# 3010 APARTMENTS

3010 & 3014 SW AVALON WAY, SEATTLE, WA

SDCI Project #3035979-LU  
Recommendation Meeting  
Southwest Design Review Board

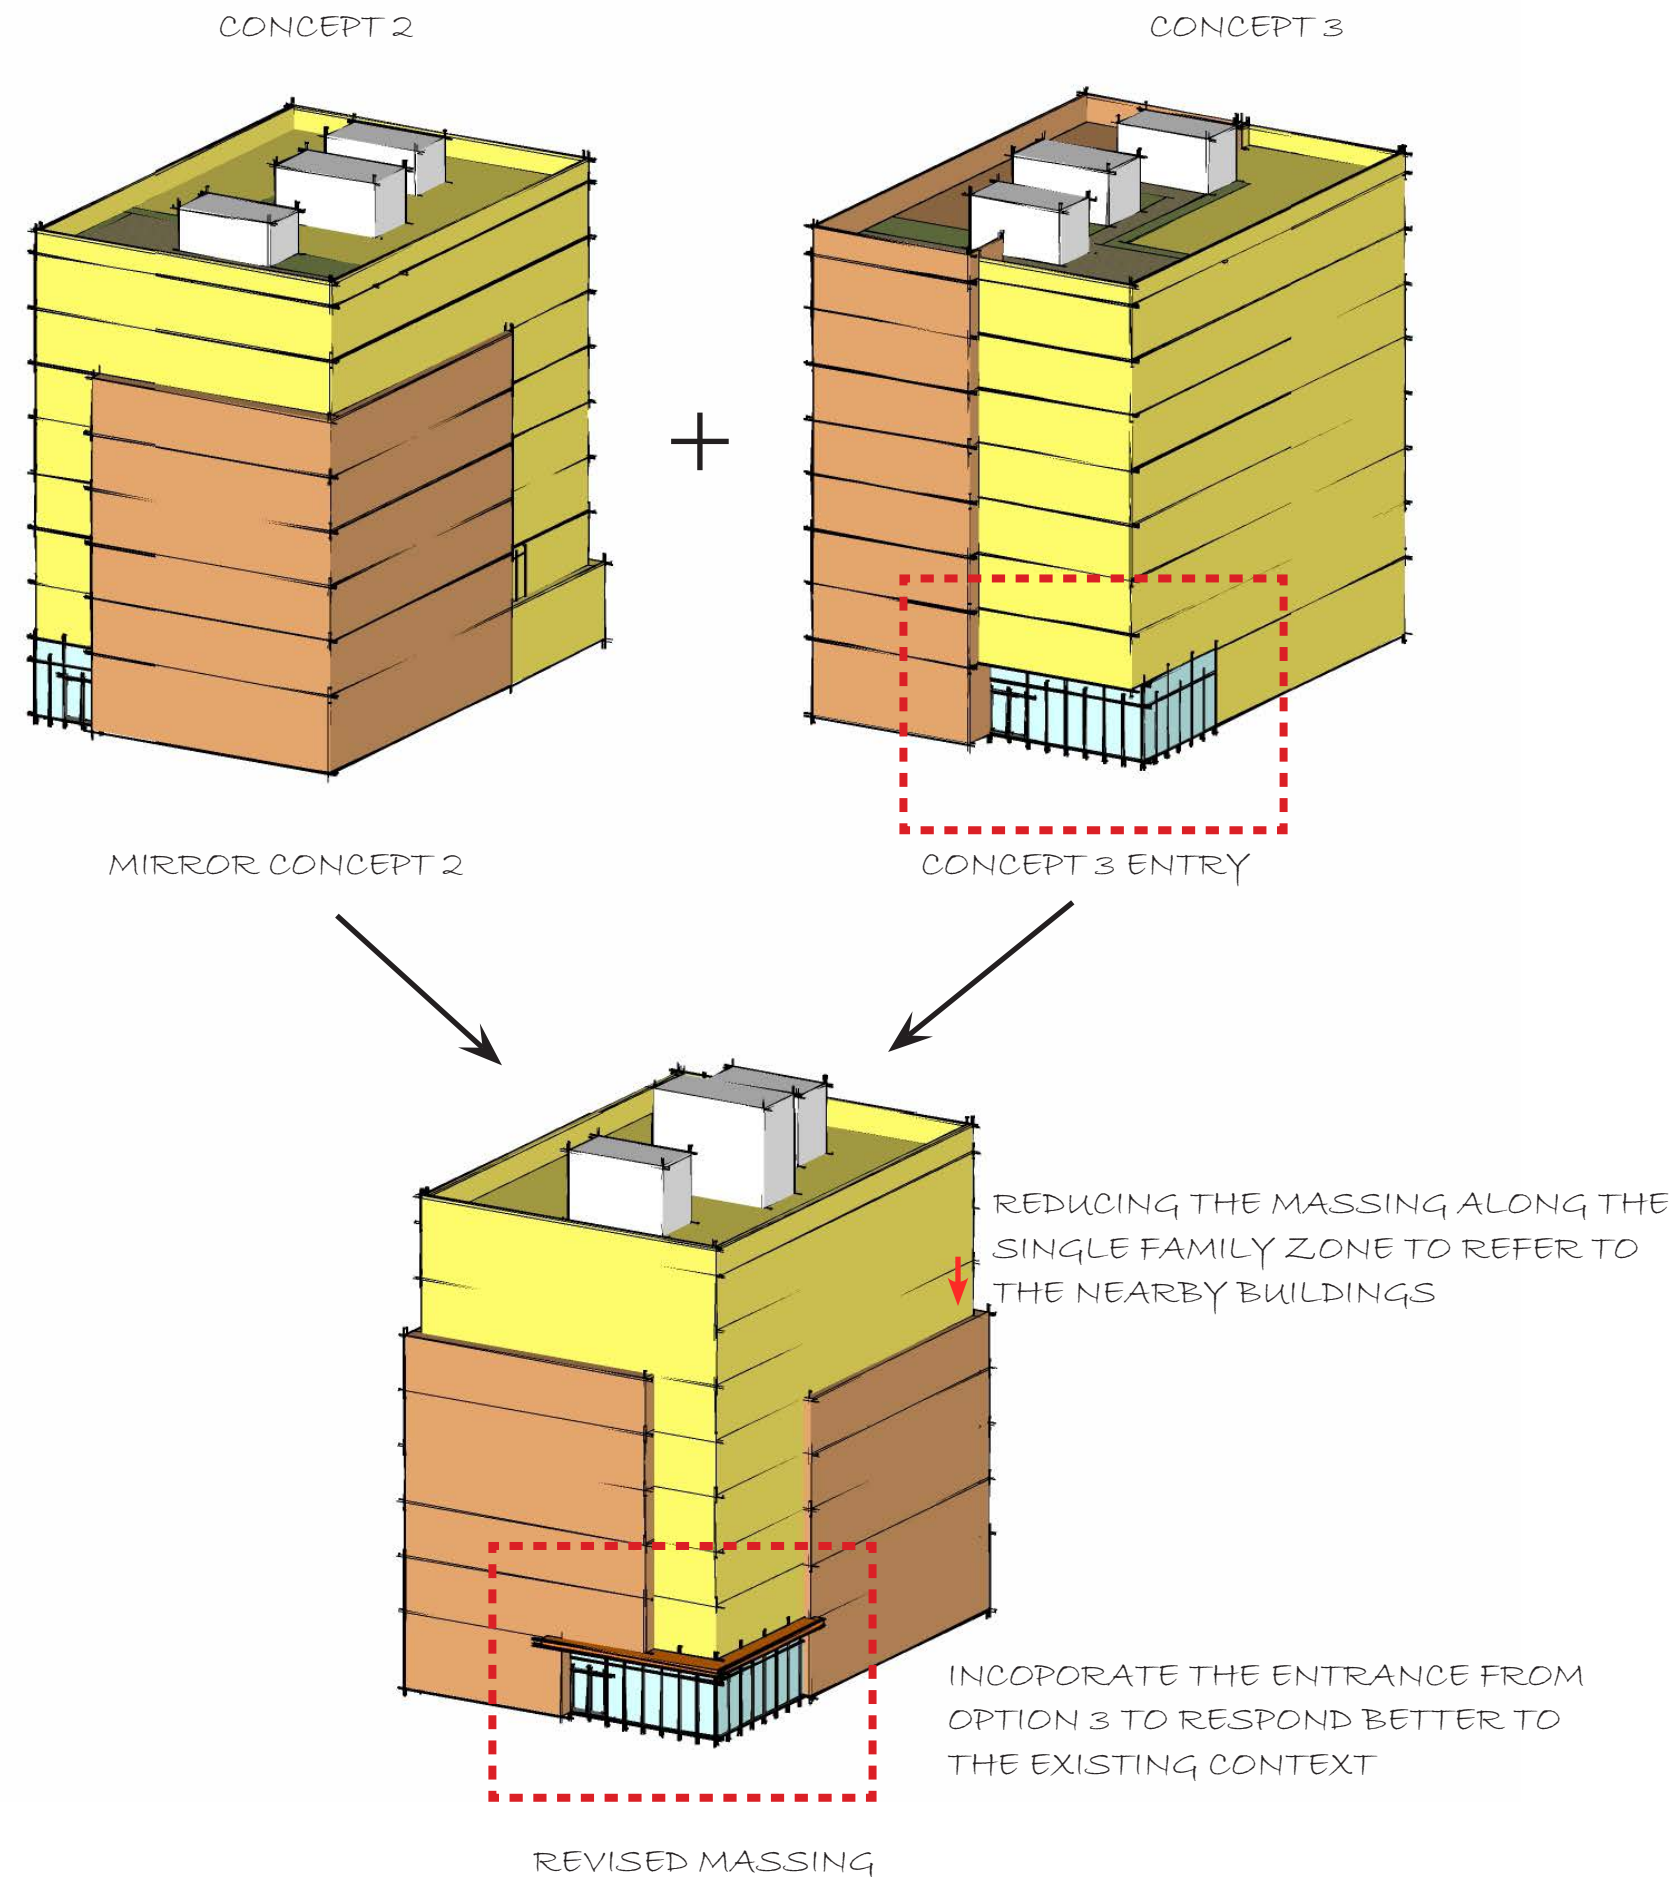
a. The Board noted that large massing moves are difficult to make without losing floor space on a small site such as this one. The Board also acknowledged the concerns voiced in the public comments regarding the scale of the project in the context of a lower scale and single family neighborhood. The Board noted that the applicant preferred Massing Concept 3 ('Shifting') had a simplistic elegance, but the massing forms conveyed a verticality that indicated no relation to context of the site and appeared to accentuate the height of the building. The Board observed that Massing Option 2 ('Intersecting') provided opportunities, with the projecting masses, to relate and respond to neighborhood cues. The Board noted that Concept 2 also stepped back the massing at the upper levels, reducing the perceived mass along the street frontage as well as at the zone transition to the rear of the site. The Board gave guidance to further develop Massing Concept 2, but to modify it to be mirrored along the frontage. This may allow the base mass and projecting elements to respond better to the existing architecture of the building to the north and would appear to step with the grade as the street rises to the south. (CS2-B, CS2-C-2, CS2-D-3, CS2-D-4, CS2-D-5, and CS3)

The design has been further developed based on Massing Option 2 per the Board's recommendation and has been mirrored in order to respond better to the context and site topography. The design change also moves the residential lobby and plaza to the north side of the site per the Board's recommendation, which open up that side of the site and allows better access from the street.

MAIN ENTRANCE - AVALON WAY

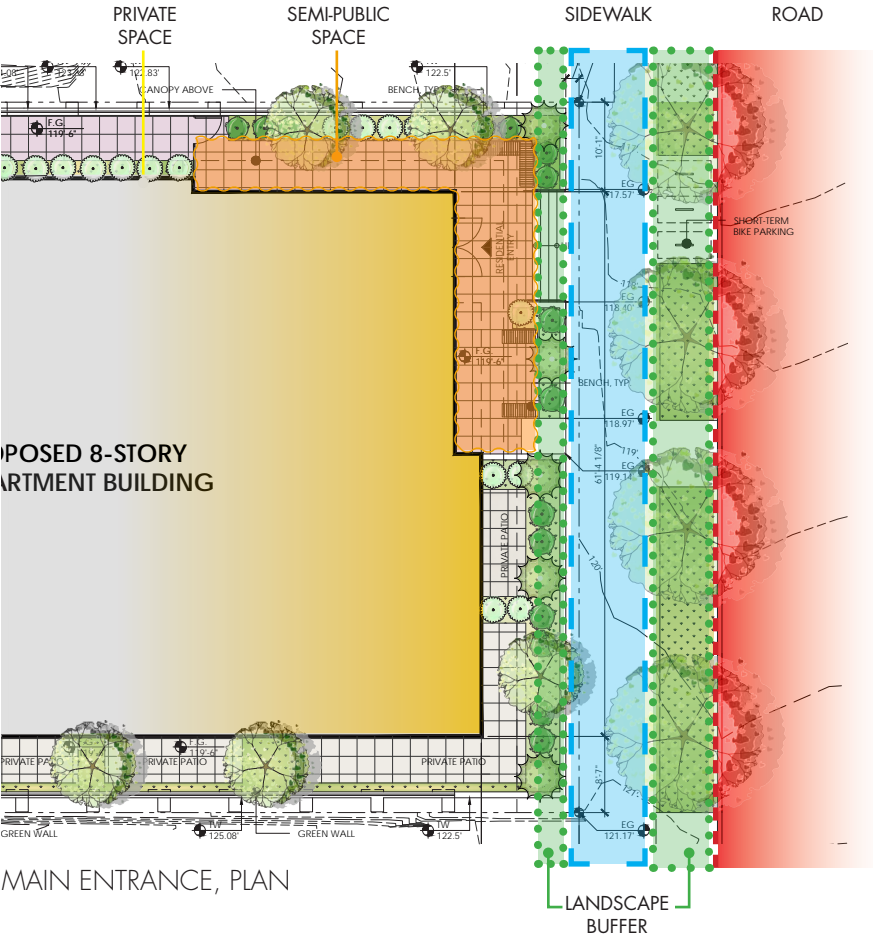
a. The Board supported the general entry sequence layout of Massing Concept 3. The layout creates a semi-public entry patio towards the northeast corner of the site, where it would sit slightly above the sloping grade of the sidewalk, creating an activated gathering space along the street frontage. The Board noted that if Massing Concept 2 is mirrored, the entry door would be oriented towards the northeast, similar to the entry in Massing Concept 3. The Board gave guidance to develop the design of this entry, using the positive aspects of the entry shown in Massing Concept 3. (PL3-A, PL3-B-4, DC2-II-i, and CS1-C-2)

The residential entrance has been moved to the northeast corner of the building per the Board's recommendation and works well with the location in the building as well as with the topography of the street, allowing the plaza to be slightly elevated and create a semi-public plaza space. The design of the plaza includes landscaping planters, seating and covered space along the building frontage which will activate the plaza for the residents and community alike.

3RD FLOOR ENTRANCE - ALLEY

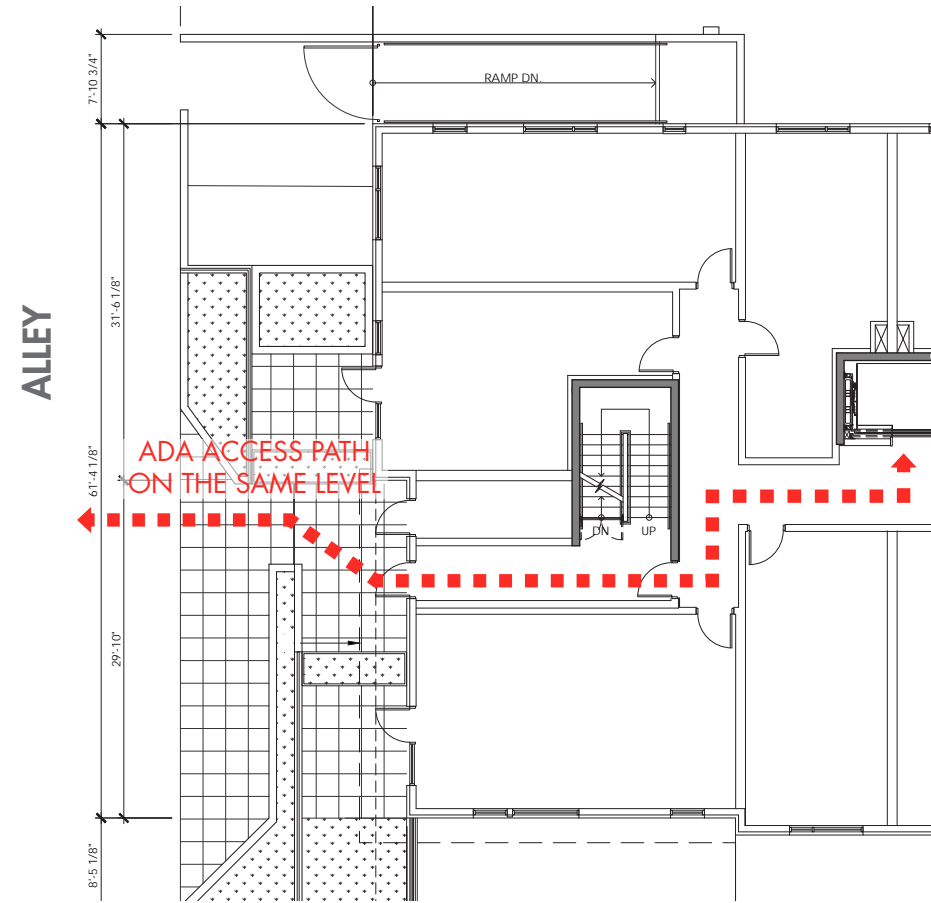
c. The Board was concerned with the grade relationship of the building to the sloping alley condition. Specifically, the Board did not support the extensive ramps shown in Massing Concepts 1 and 2 to provide ADA access between the parking and the access door. They noted that the general access approach shown in Massing Option 3 was better but questioned the inconvenience of an interior lift to make ADA access work. The Board gave guidance that the rear access door level should be coordinated with the interior floor levels to provide convenient access from parking and deliveries to the interior. (PL2-A, CS1-C, PL4-A, and DC1-B-1)

The parking area has been removed from the project and a courtyard for the residents has been added in this area. The doors from the building are very close to the grade of the alley in this location now and allow for a minimal ramp to connect to the alley. The plaza has been designed as a gathering space with seating, landscaping and a covered area along the building façade.

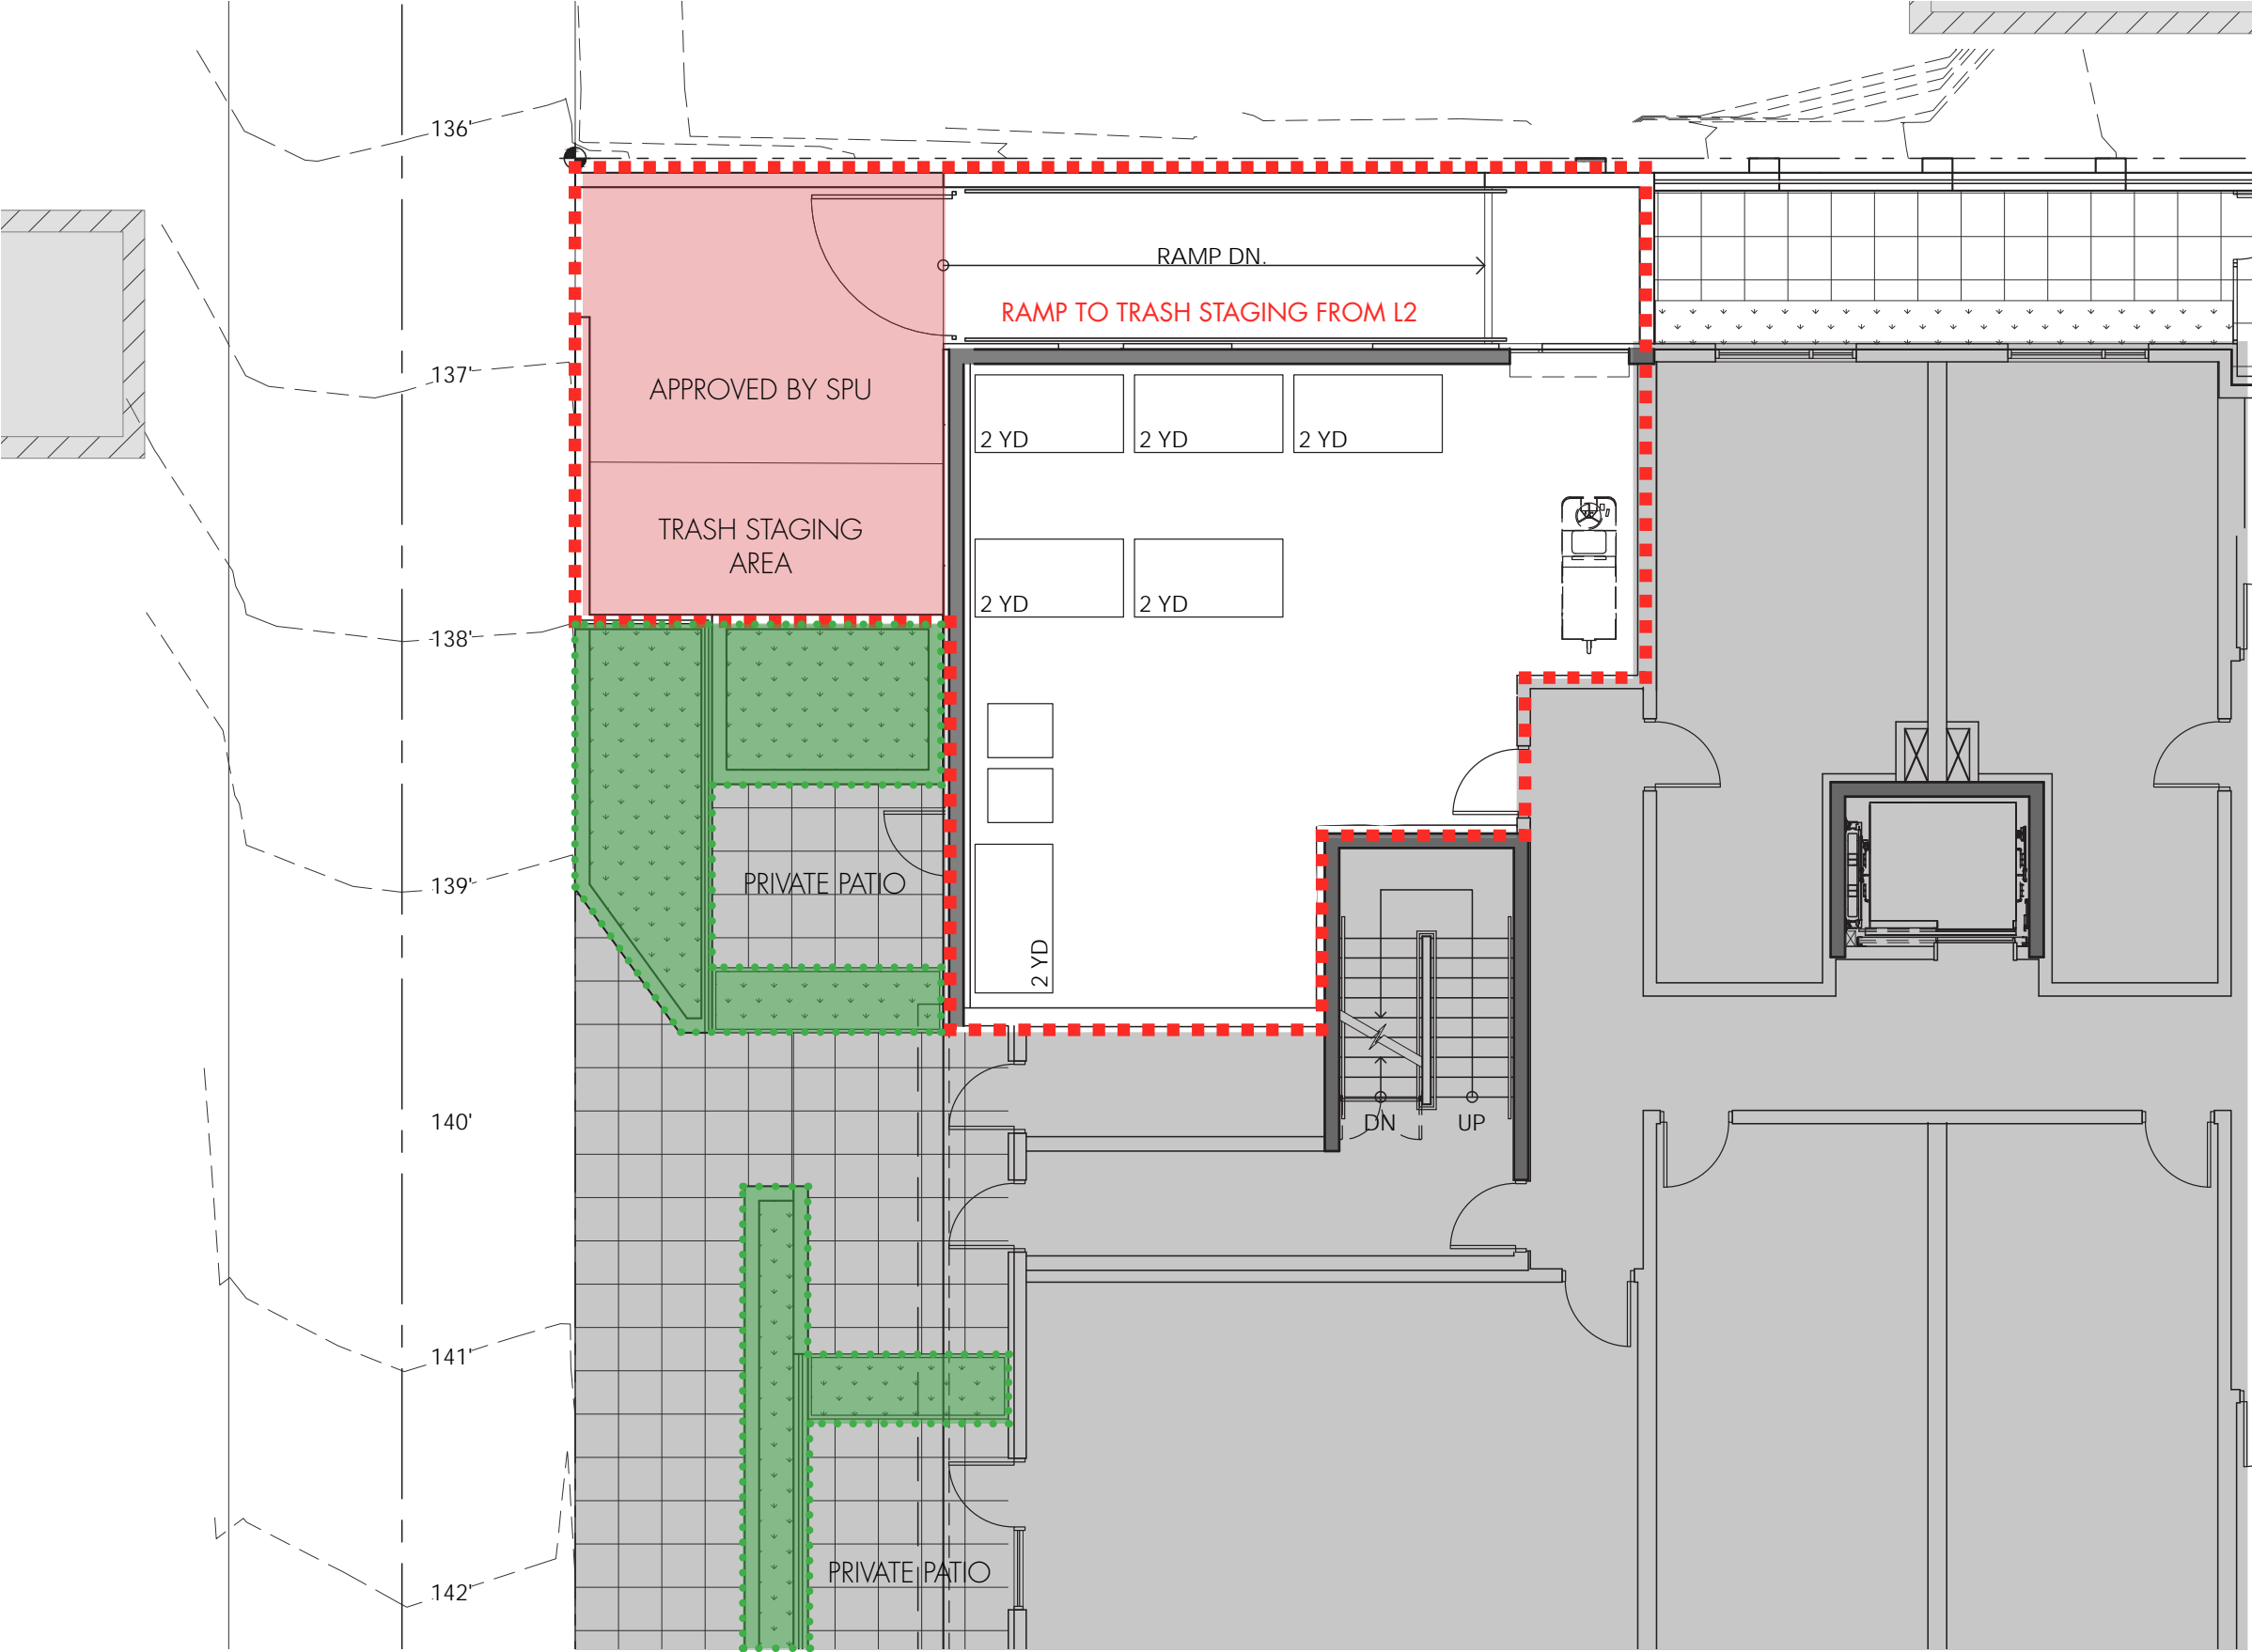
d. The Board questioned how the solid waste storage and service would occur along the alley. As shown in all three options, the storage room is accessed via a ramp near the northwest property line. The Board direct the applicant to locate the storage area close enough to the pickup to avoid having to stage dumpsters in the alley, in order to lessen impacts to the single family neighborhood and congestion of traffic in the alley. (DC1-C-4)

We have worked with and obtained approval from SPU to have the trash collected in the building and then brought out to the staging area on site on pick up days. This will allow the trash staging to be onsite and not block any access in the alley. The staging area will also be screened from the residential courtyard by a planter wall.
